**HISTORIC PRESERVATION REVIEW BOARD
STAFF REPORT AND RECOMMENDATION**

Landmark/District:	Anacostia Historic District	(x) Agenda
Address:	1328 W Street SE	
Meeting Date:	November 19, 2015	(x) Alterations
Case Number:	16-057	(x) Subdivision
Staff Reviewer:	Tim Dennée	(x) Concept

The applicant, Ronnie McGhee, architect and agent for the property owner, the D.C. Department of Housing and Community Development (DHCD), requests review of a concept to relocate the two historic houses from 2234 and 2238 Martin Luther King Jr. Avenue SE in preparation for the anticipated residential and retail construction on the “Big K” site.

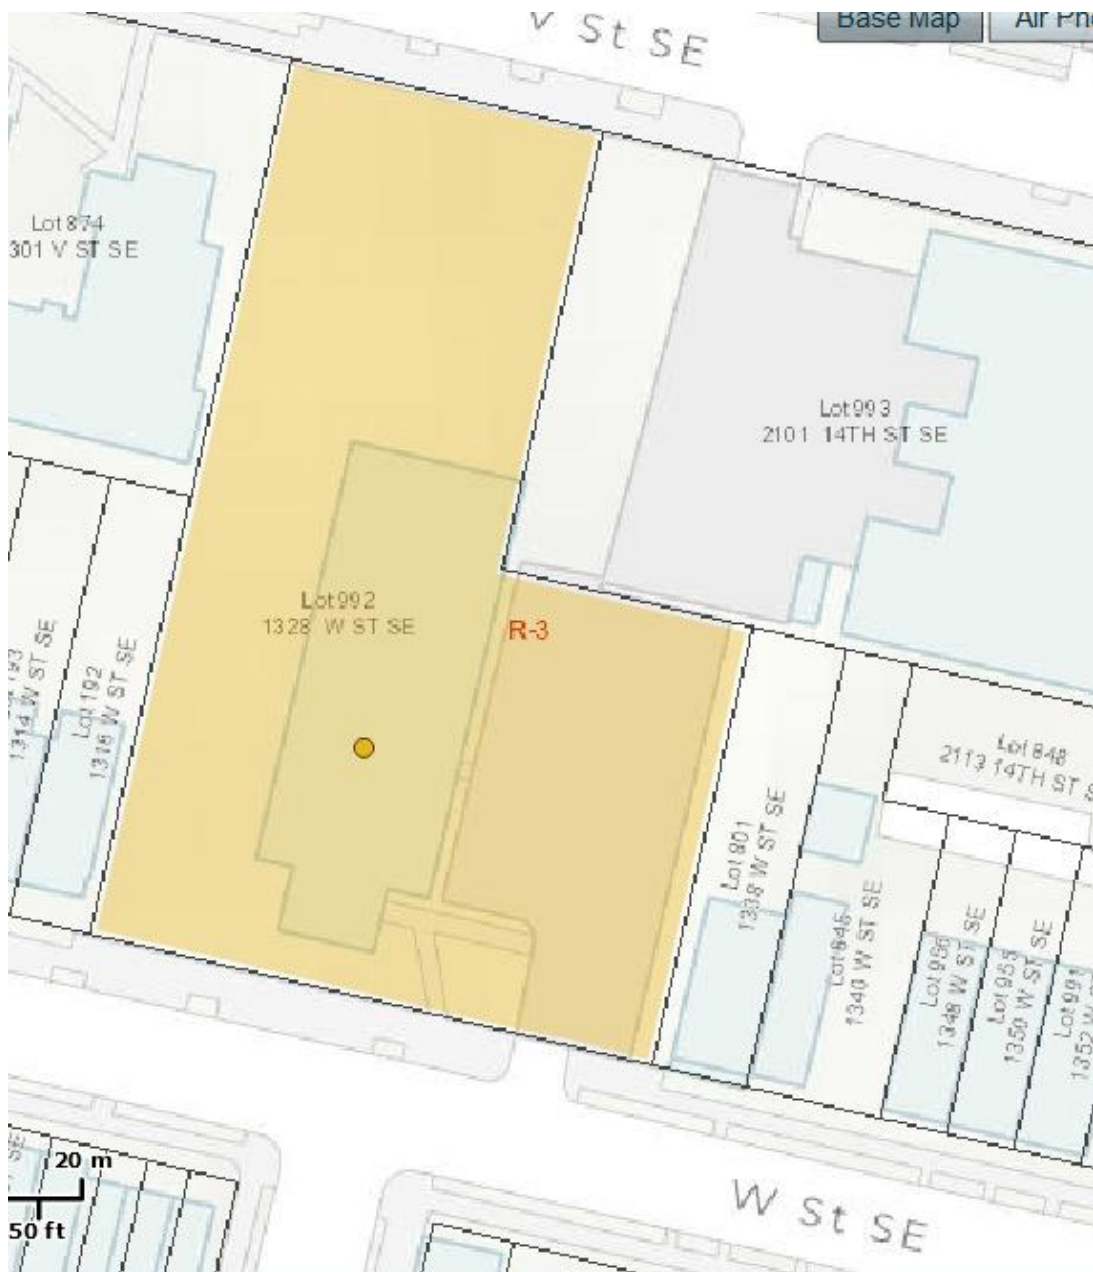
The present site plan reflects this staff recommendation, with 2238 MLK to stand on the W Street side of this through-parcel, set back to align approximately with next-door 1316 W, and 2234 to stand on V Street, with a setback similar to that of the Delaware Avenue Baptist parsonage. The V Street house's lot would stretch from the Delaware Avenue Baptist property to a new alley separating it from the firehouse parking lot. The W Street frontage would likely be carved into four lots total, permitting zoning-compliant lots for one relocated house and as many as three new ones. An alternative to the proposed lot for 2238 is to flip it to the similarly sized lot next to the alley, so that the wraparound porch faces outward.

It will be necessary to create the lots for 2234 and 2238 MLK before their move. Two parking spaces would be created at the rear of each house, accessed from the new alley. The space left for the other lots on W Street would accommodate three houses, but only if two were semidetached, which is not incompatible with the context.

The proposed elevations for the 2234 MLK house do not take into consideration the rising topography of its site. Setting the foundation and the porches relative to the slope is probably the project's biggest challenge aside from the move itself.

- The rear porch proposed for 2234 mirrors the front one. It is perfectly compatible, and some kind of porch or landing is desirable as access to the rear yard. Yet historically, a back porch would normally not be as elaborate as the front one and was most often smaller. The hip roof of the front porch should remain at its present pitch.

- The roofing materials on 2234 appear to be some kind of shingles on the principal roof and standing-seam metal on the porches. These, too, are acceptable, despite the fact that the present roofs are all metal. At least without some exploration under the present roofing, we cannot know the original materials for sure, as there appears to be no extant permit for this late 1870s house. Metal was widely available at that time and often used in rural contexts, as were wood shingles. Asphalt shingles have often been permitted in the formerly suburban areas (such as Anacostia and Takoma Park) as a substitute for the original wood shingles, but metal throughout would be a more compatible choice for an early cottage-style house of this caliber.

- The replacement door for the front of 2234 should be of a more Italianate sort, perhaps four-panel, or with some glazing replacing the upper panels.
- Because 2238 was expanded and renovated during its first few decades, it does not represent a pure example or even a vernacular interpretation of a style. The house dates to about 1885, but the front mansard roof and the wraparound porch probably date to a 1911 renovation. The drawings do not state that the mansard's slates would be replaced, but that roof requires repair at least, and replacements should match the original material. The ridge detail should be replaced or replicated, too.

- The appropriate profile and exposure of the siding of 2238 should be exposed when the stucco is removed. It should be replicated.
- The present porch reflects the 1911 renovation, and replicating it is a better approach than trying to evoke the house's 1880s appearance, which was lost with the alterations. Therefore, the Tuscan columns (presently boxed with plywood) atop piers should be retained or replicated, rather than replacing them with full-height columns.

- The porch on 2238 now has a nearly flat roof. On these, the water collected in a drain and was conducted into a downspout along the house wall or down a pier. The roof edge is not boxed and has no drip edge, but rather a molding. The drawings indicate a roof that would now shed outward. This is acceptable if the roof is low-pitched so the roofing is not seen, but it raises the need to incorporate a perimeter gutter against the roof edge.

The HPO recommends that the Board approve the subdivision, site plan, additions and alterations and repairs in concept as consistent with the preservation act and Mayor's Agent order, and delegate final review to staff with the condition that the applicant address the comments above and that, at the time the houses are moved, they be placed immediately on their permanent foundations.
